**COUNTY OF VENTURA
PUBLIC WORKS AGENCY**

Addendum No.1

Subject: **tšumaš Creek Improvements Hueneme Road to Upstream of Jane Drive.
Specification No. WP21-01; Project No.: 82323
Bids to be Opened Thursday, October 15, at 2:00 PM**

NOTES:

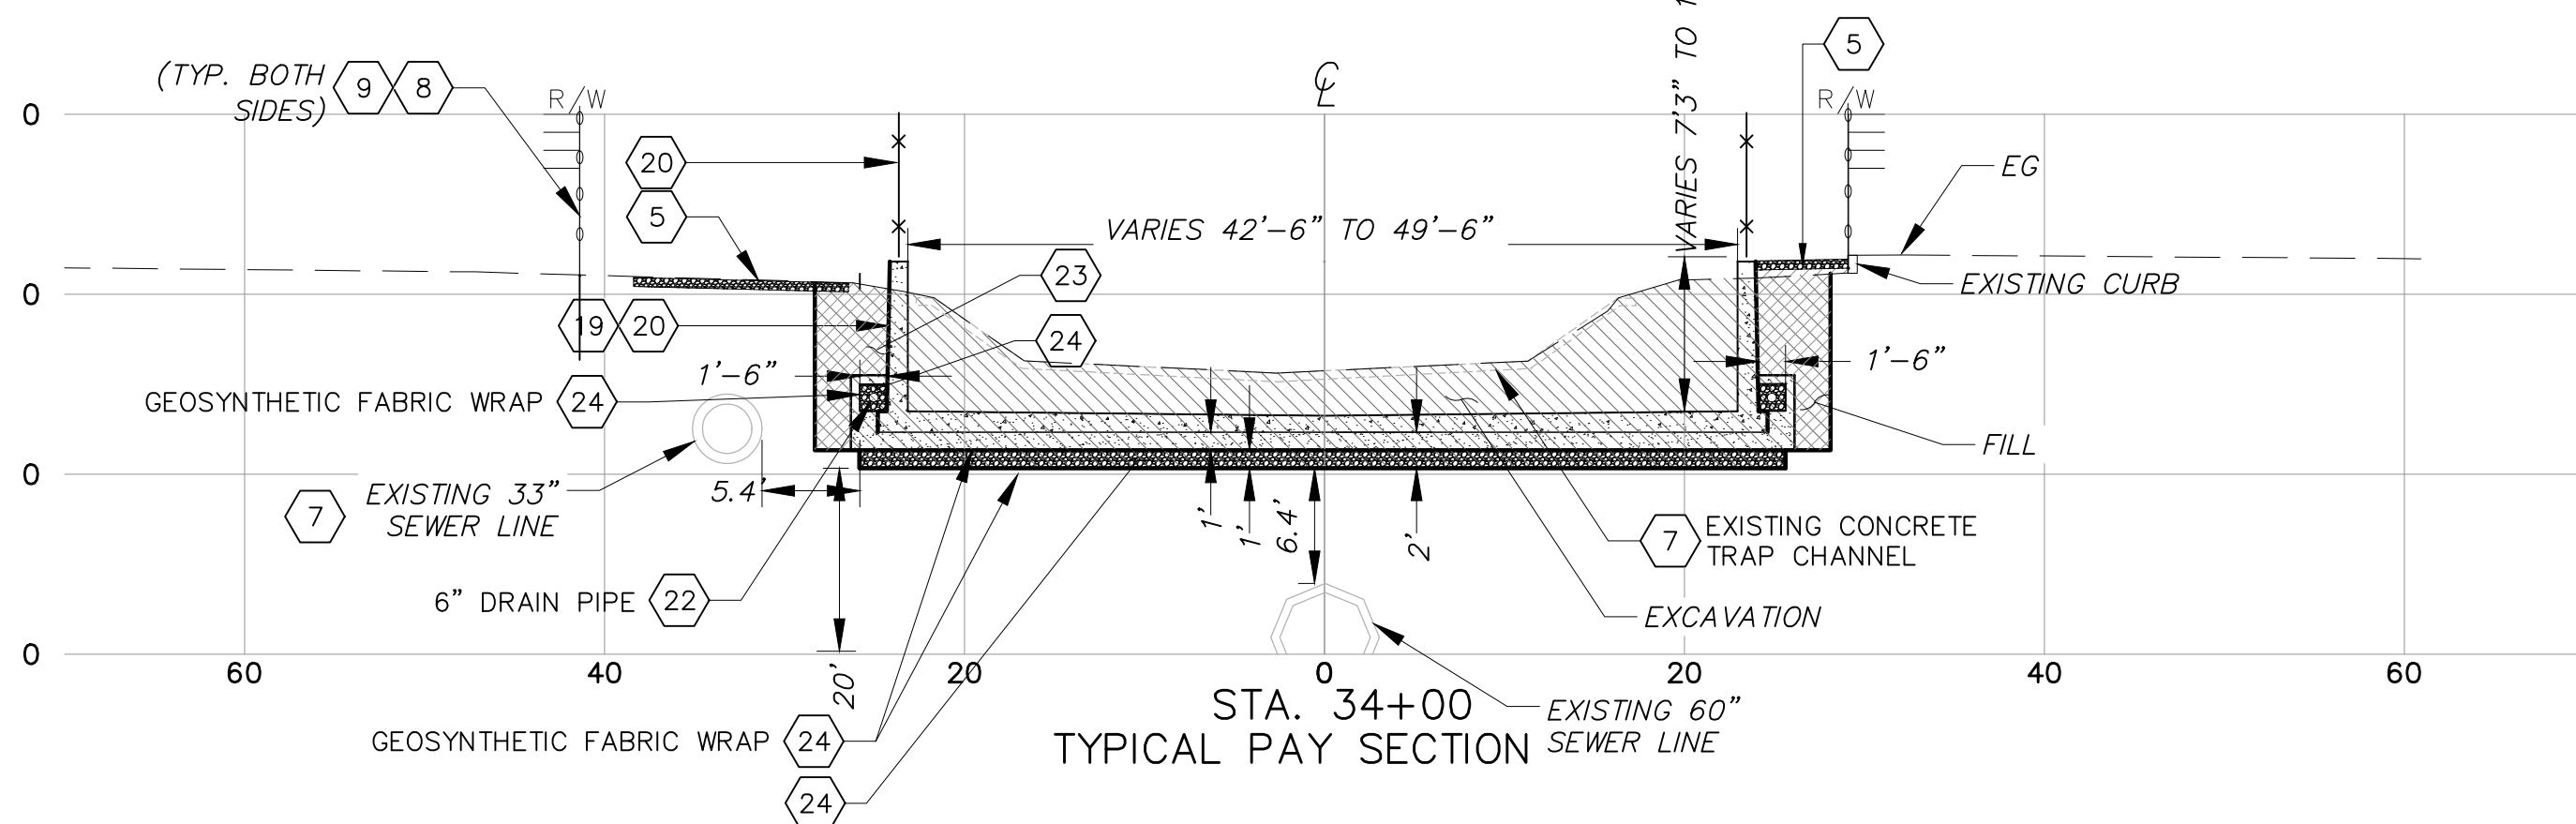
10. Replace sheet 25 OF 30, "CROSS SECTIONS STA 37+50 TO 41+00" with the attached, revised sheet 25 OF 30 to update with the new subdrain detail.
11. Replace sheet 26 OF 30, "CROSS SECTIONS STA 41+50 to 42+40" with the attached revised sheet 26 OF 30 to update with the new subdrain detail.
